ADDENDUM 01

Project Title: **Blinn Mechanical Project – Brenham – Melcher + BCPA Phase 2**
RSE Project #: **1540**

This **ADDENDUM** shall modify, amend, extend and become a part of the Contract Documents dated 1/13/25 prepared by Ramirez Simon Engineering, LLC (RSE) in accordance with the terms therein, as if written out in full therein and bound originally therewith.

2 ELECTRICAL MELCHER ENLARGED DEMO PLAN - ATTIC
1/4" = 1'-0"

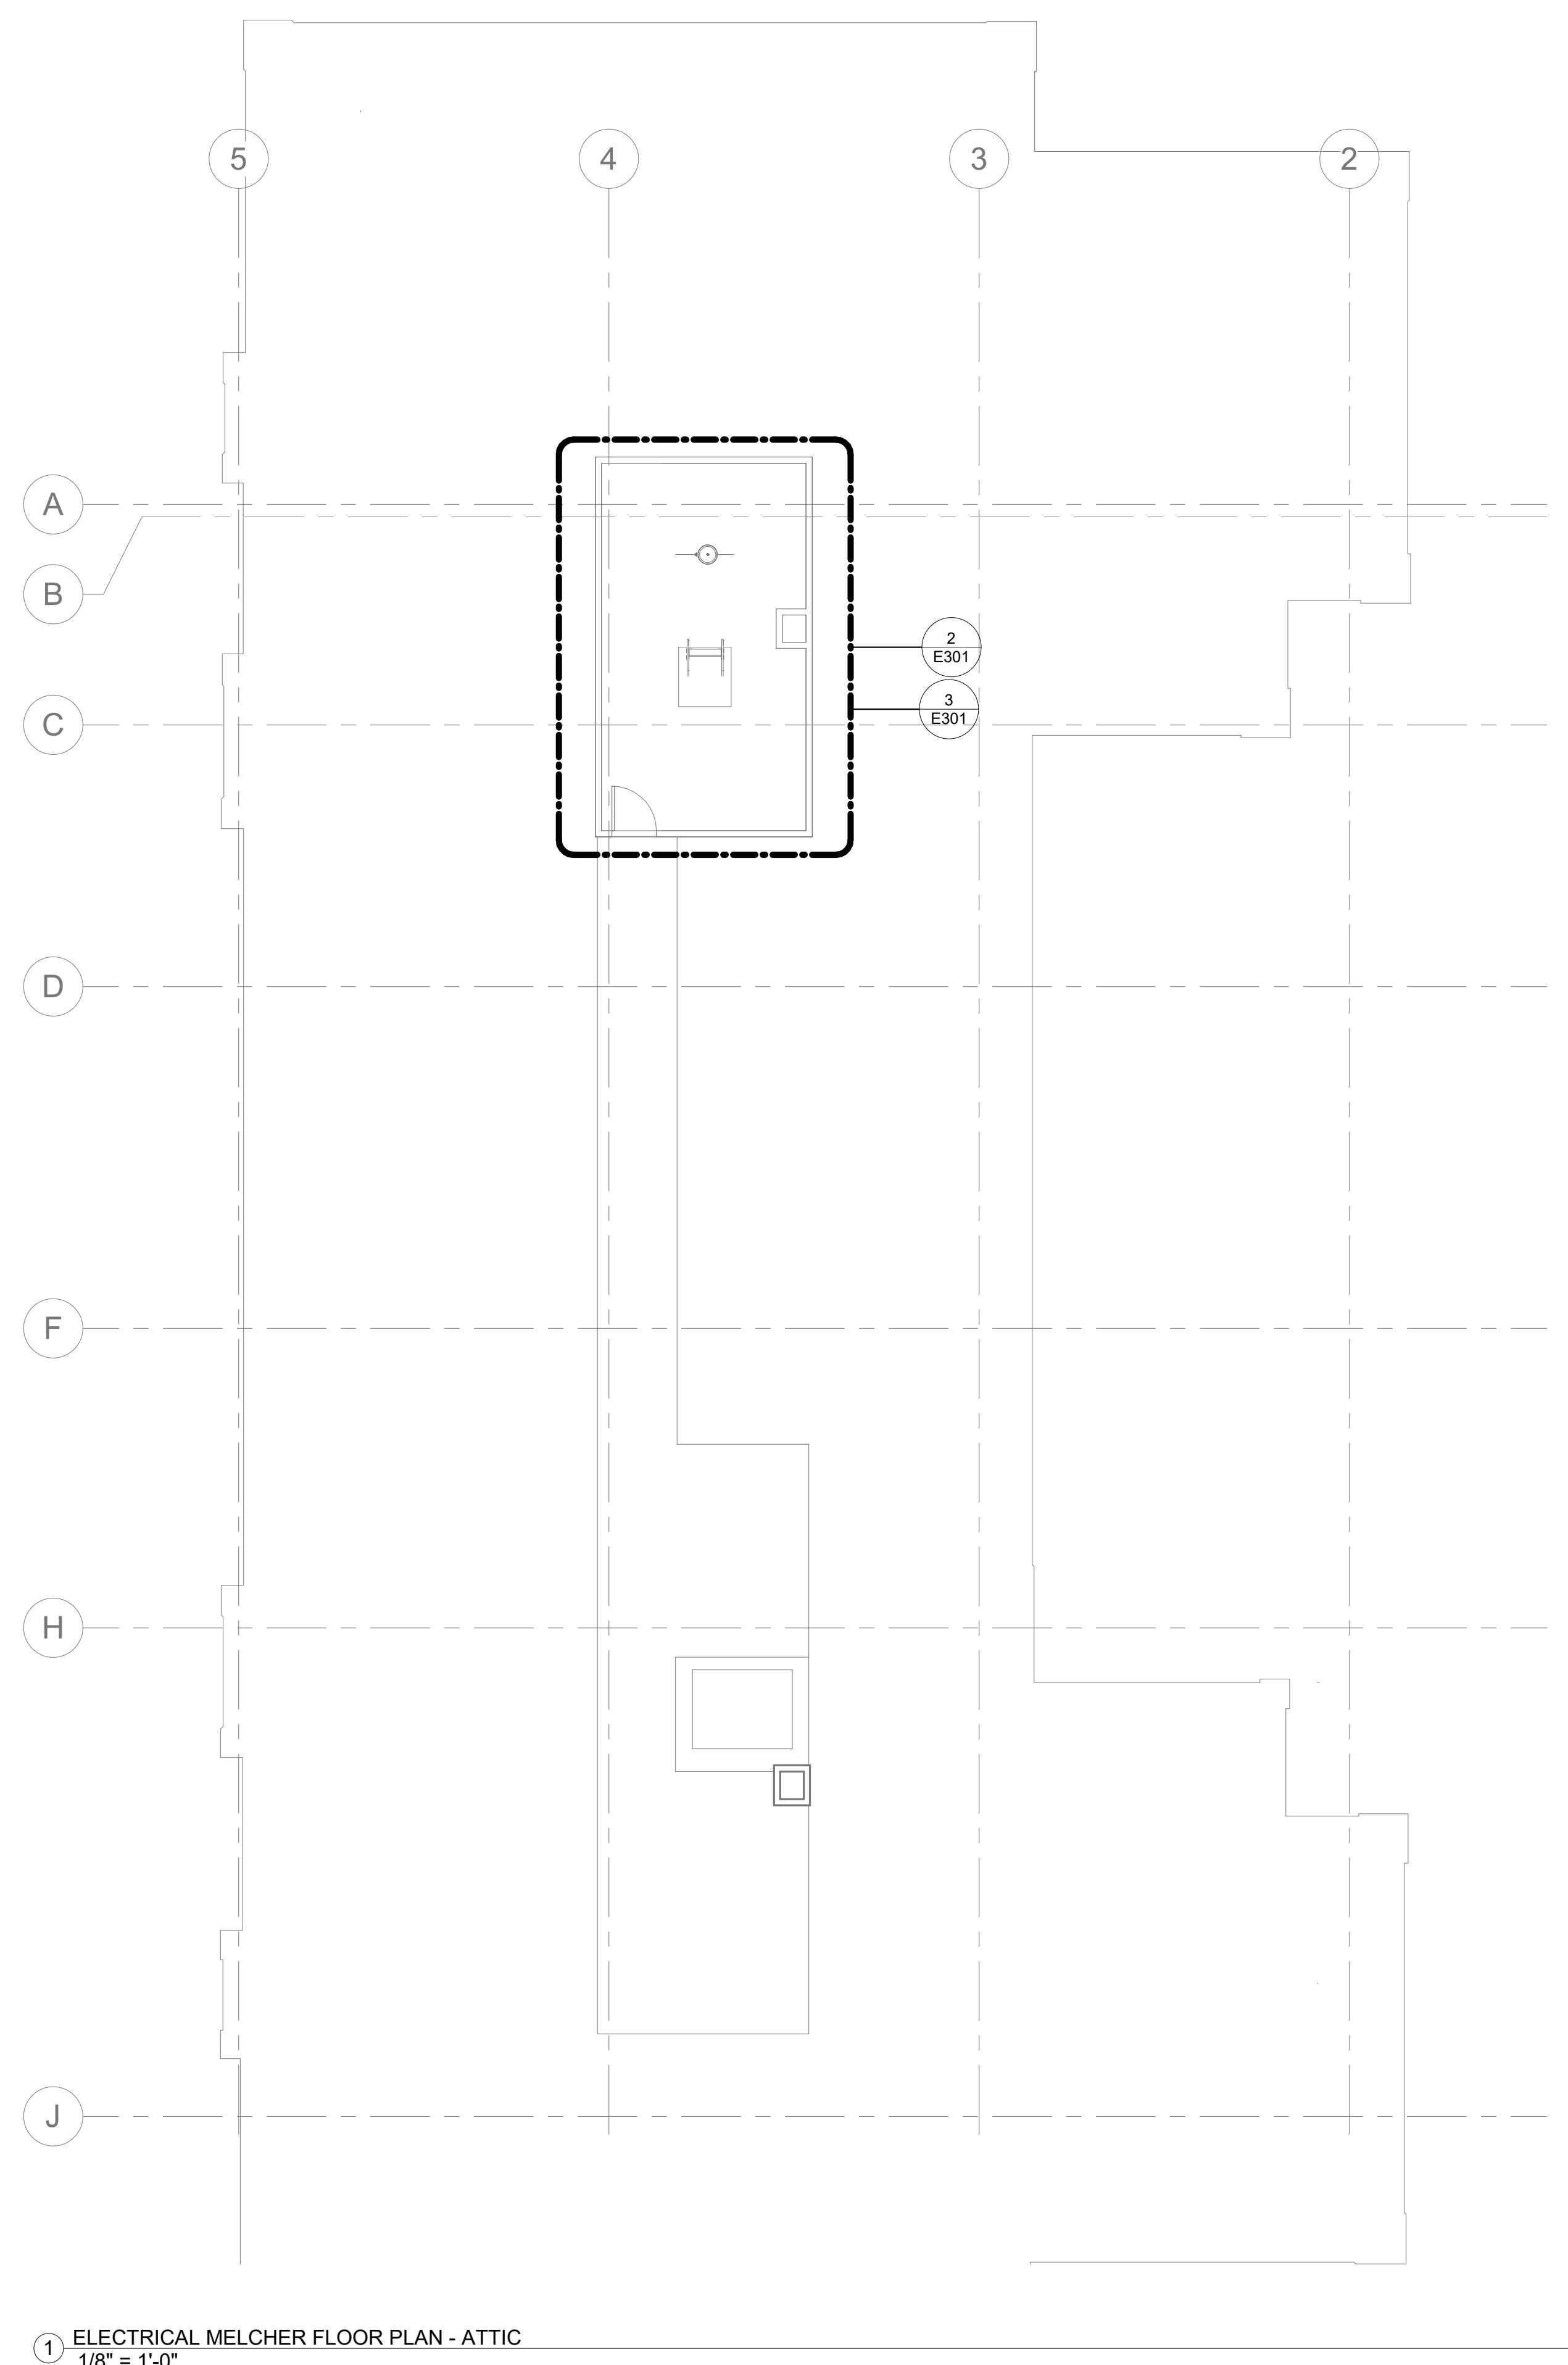
1. E301-ELECTRICAL MELCHER FLOORPLAN
 - a. Updated Fixture Tag from B-3 to B-1 for new boiler.

ELECTRICAL BCPA2 FLOOR PLAN

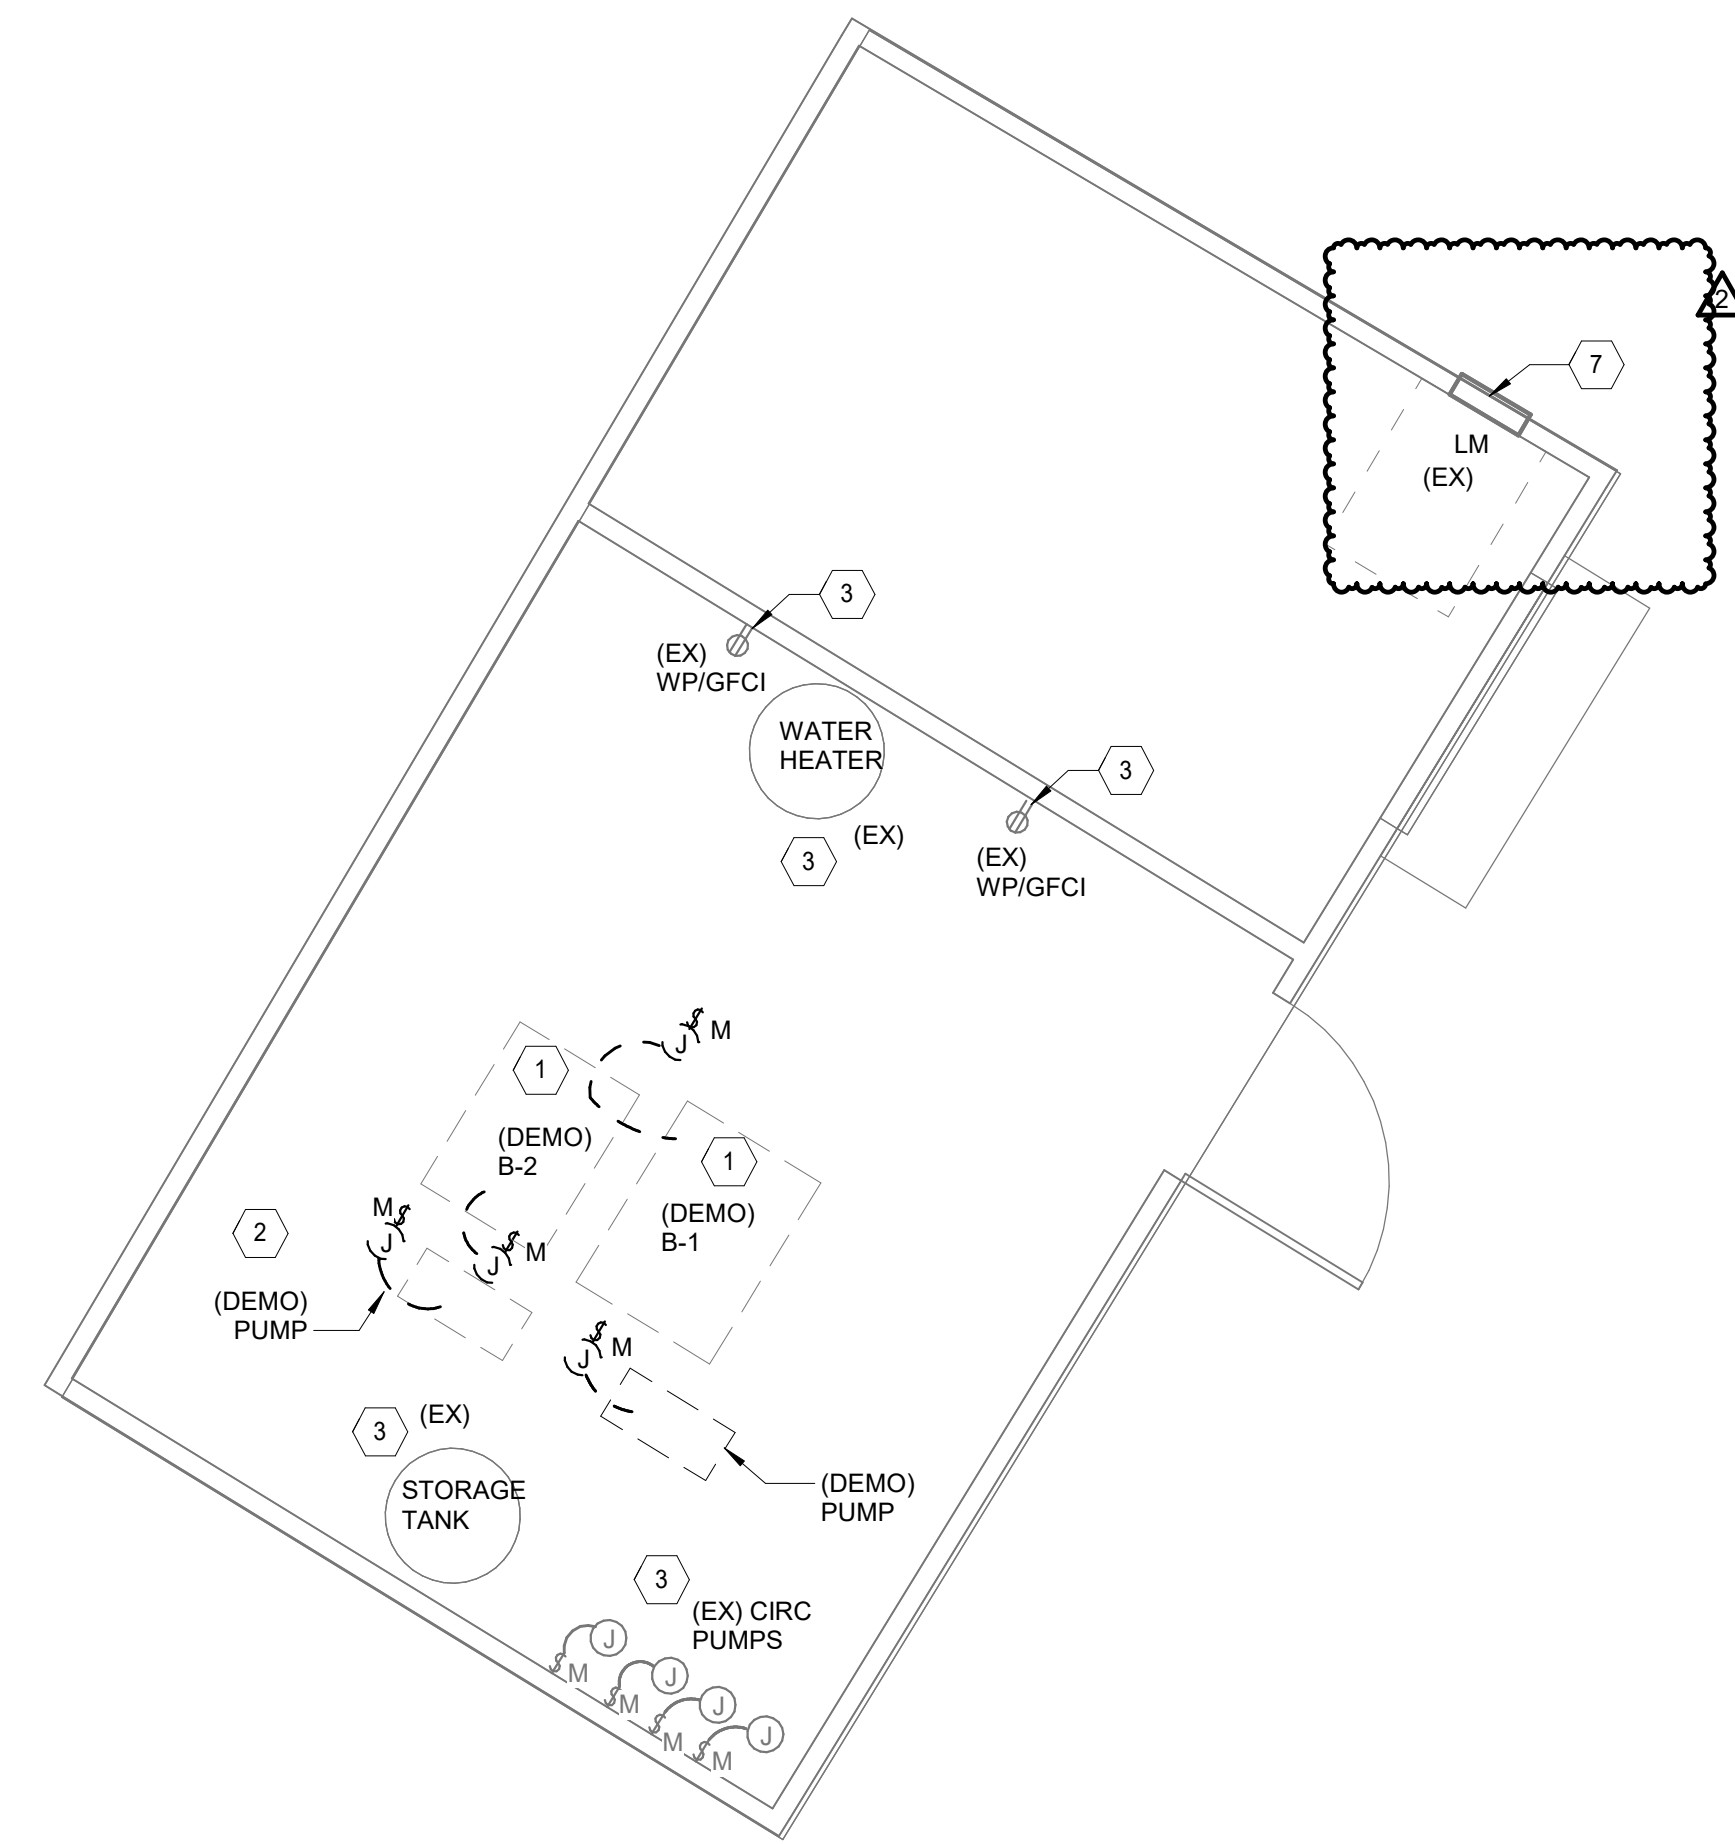
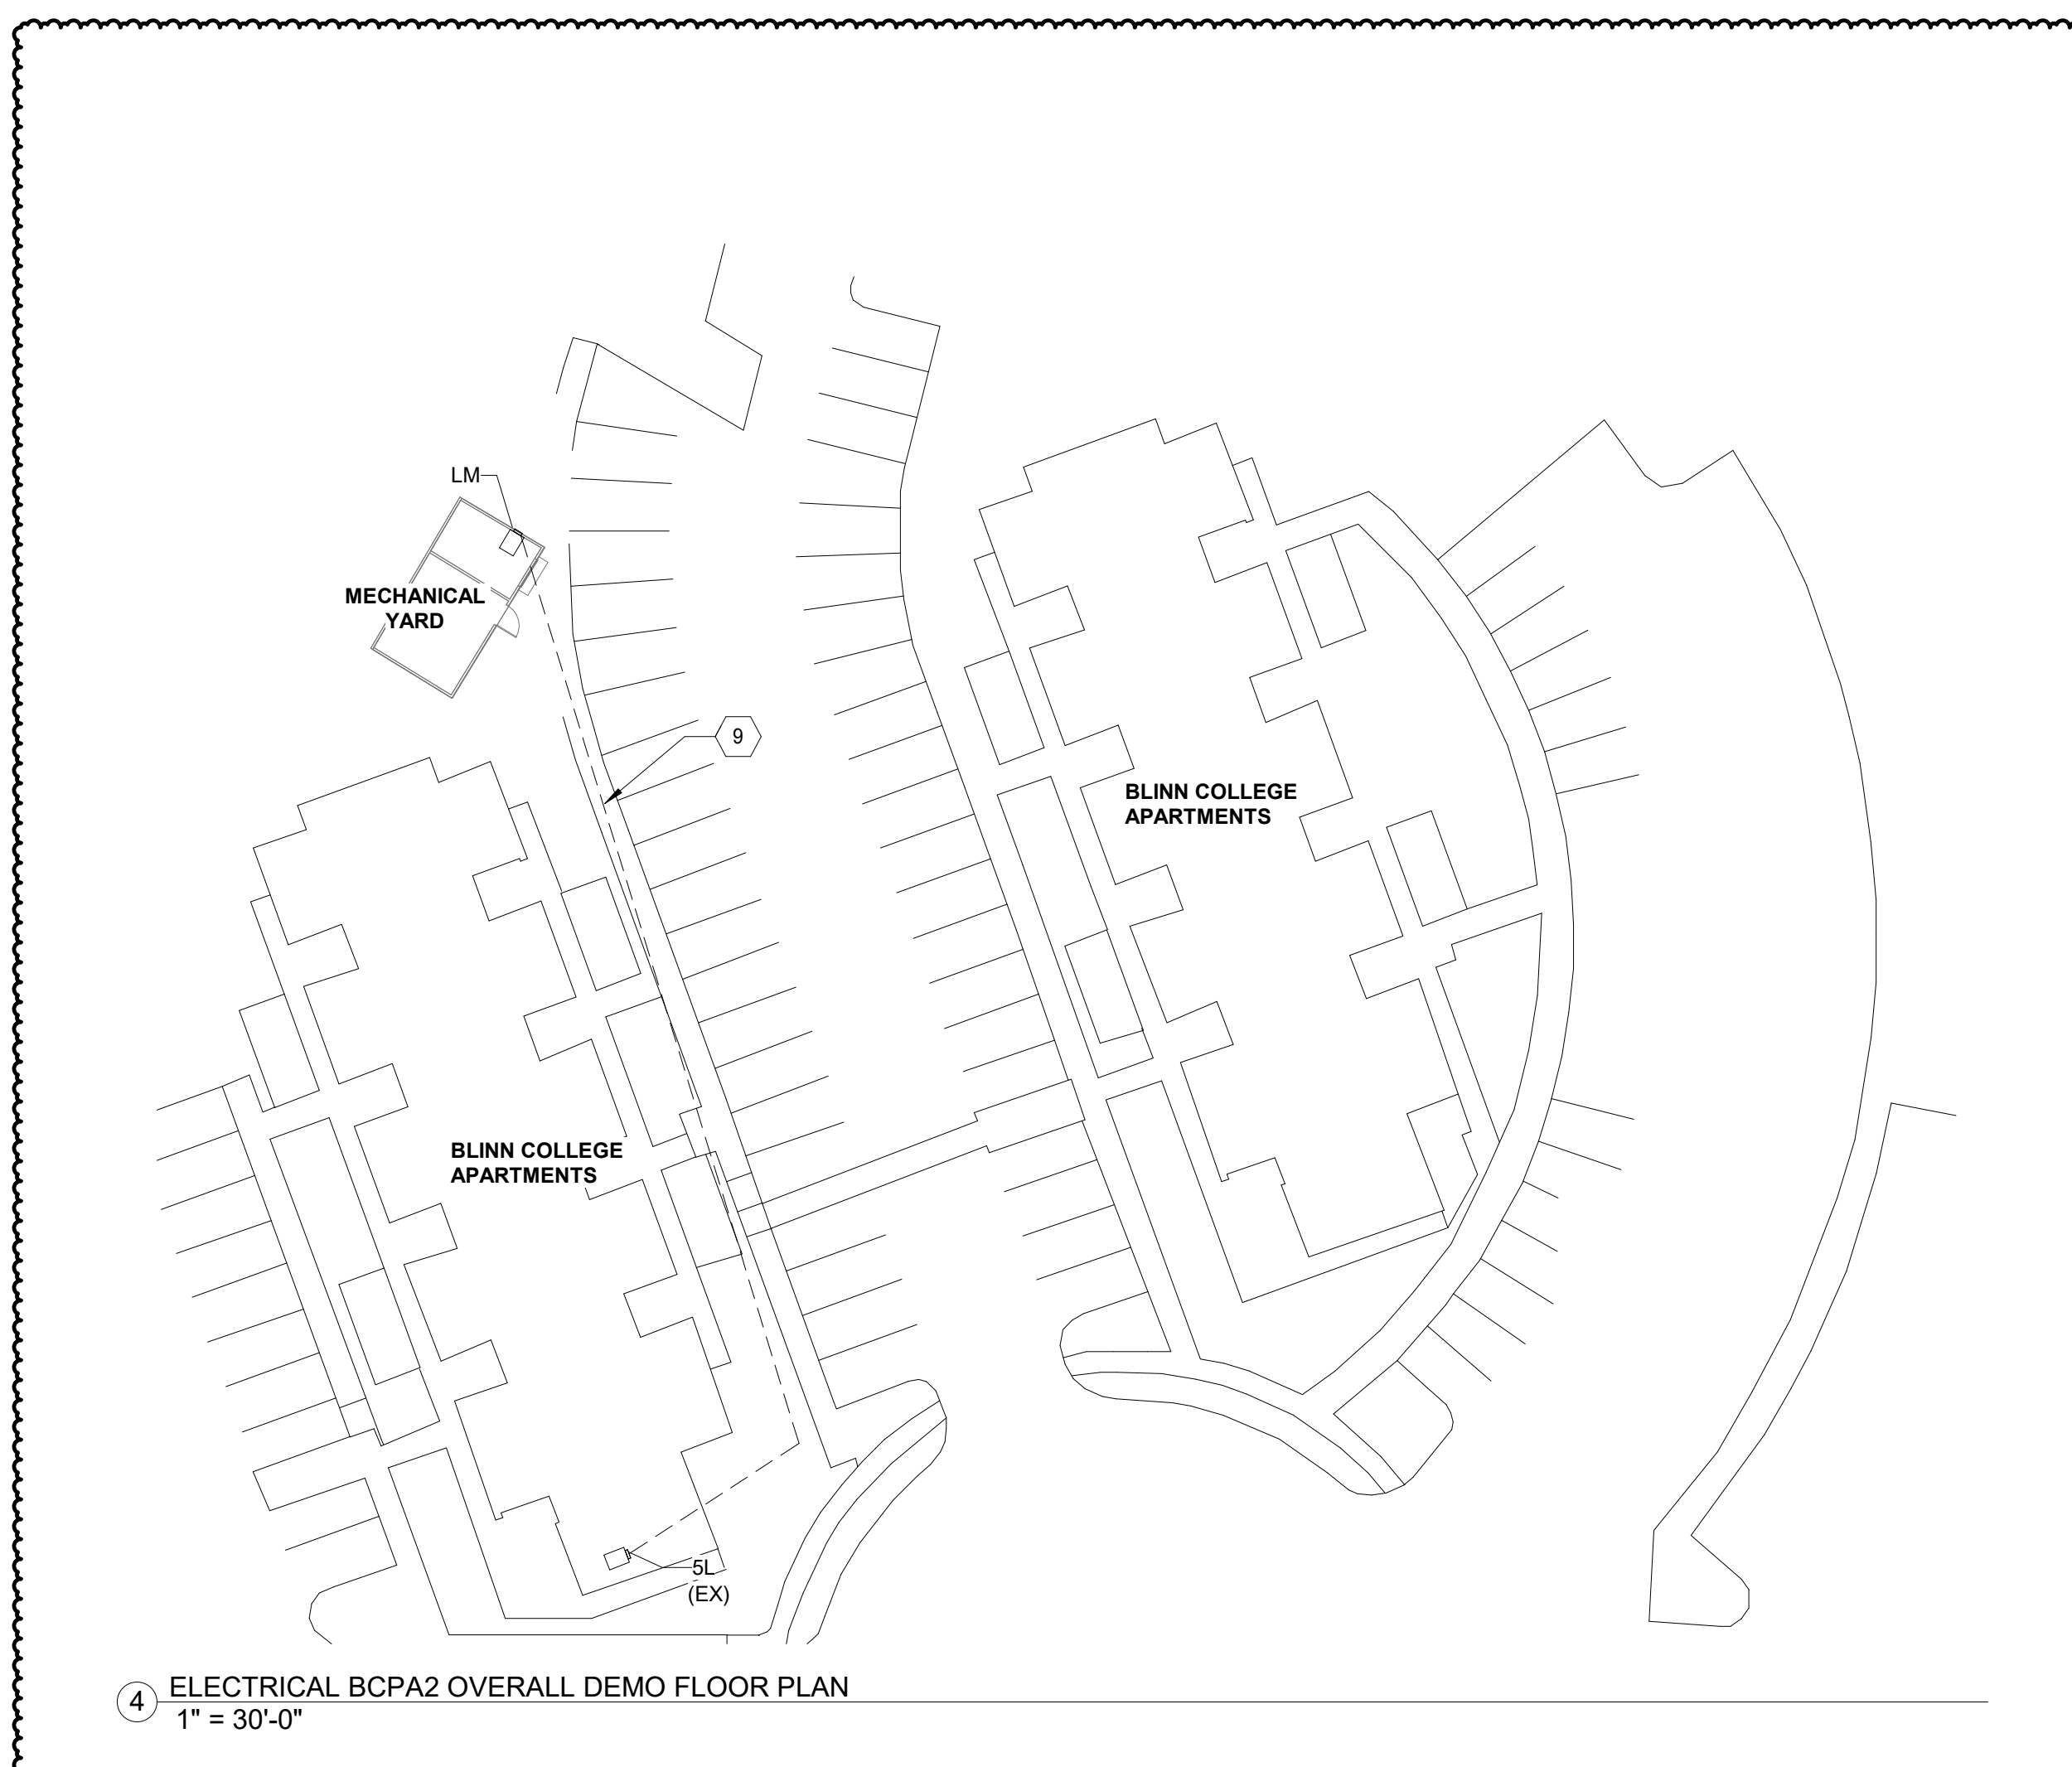
2. E302-ELECTRICAL BCPA2 FLOORPLAN
 - a. Added scope to replace panel LM under Alternate #1. This includes replacing the existing feeder served from panel 5L.
 - b. Added demo floor plan to demolish the existing feeder for panel LM under Alternate #1.
 - c. Added routing for new feeder to serve panel LM under Alternate #1 to the overall floor plan.
 - d. Qty of tankless heaters has changed from 14 to 8. Tags for tankless heaters was changed from BI-1 and BI-2 to TWH-1.
 - e. Added power for additional tankless heaters TWH-2 under Alternate #1.
 - f. Circulation pump CP-2 has been removed.

- g. Updated circuiting for CP-1.
 - h. Removed power for heat tracing control panel HTCP-1.
